Z-27
(2017)

Rezoning Plat

766 and 770 Ledford Street

Z-27 AMRETECK, LLC

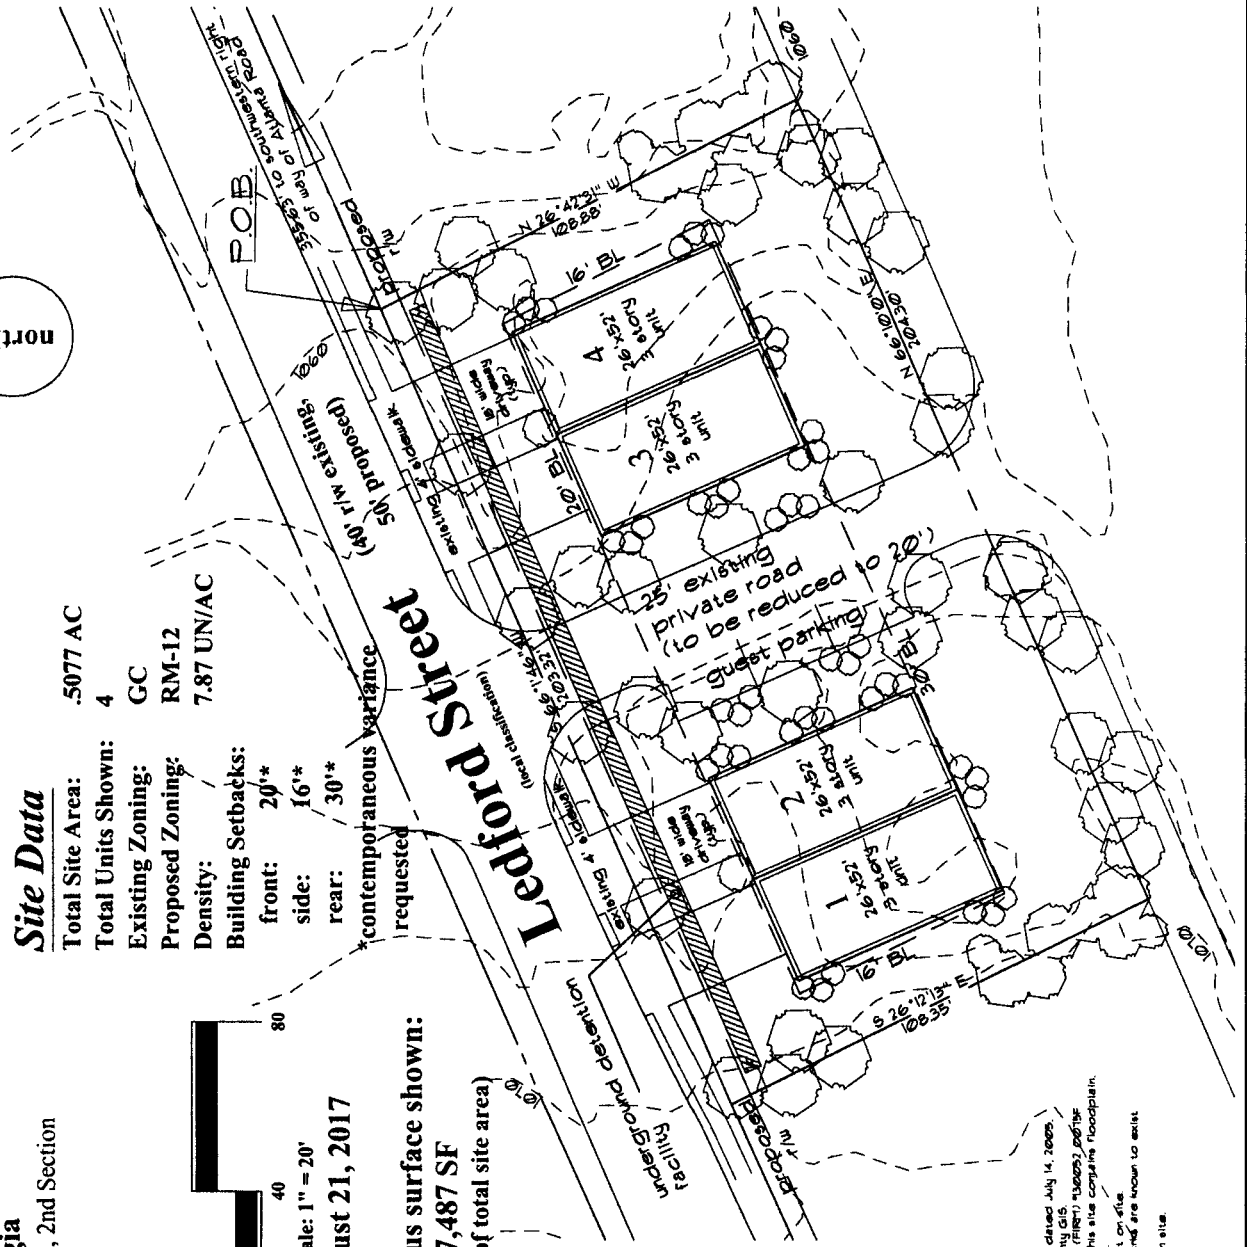
The proposed site plan will require the following contemporaneous variances;

1. Waive the minimum lot size from 80,000 square feet to 22115 square feet;
2. Waive the front setback from 50 feet to 20 feet;
3. Waive the side setbacks from 35 feet to 16 feet.
4. Waive the rear setback from 40 feet to 30 feet.

- Provide comprehensive hydrology/stormwater controls to include development of out parcels.
- Submit all proposed site improvements to Plan Review.
- Any **spring activity** uncovered must be addressed by a qualified geotechnical engineer (PE).
- Structural fill _____ must be placed under the direction of a qualified registered Georgia geotechnical engineer (PE).
- Existing facility.
- Project must comply with the Water Quality requirements of the CWA-NPDES-NPS Permit and County Water Quality Ordinance.
- Water Quality/Quantity contributions of the existing lake/pond on site must be continued as baseline conditions into proposed project.
- Calculate and provide % impervious of project site.
- Revisit design; reduce pavement area to reduce runoff and pollution.

Ledford Street is classified as a local and according to the available information the existing right-of-way does not meet the minimum requirements for this classification.

Recommend applicant consider entering into a development agreement pursuant to O.C.G.A. 36-71-13 for dedication of the following system improvements to mitigate traffic concerns: a) donation of right-of-way on the south side of Ledford Street, a minimum of 25' from the roadway centerline.

Recommend curb, gutter, and sidewalk along the Ledford Street frontage.
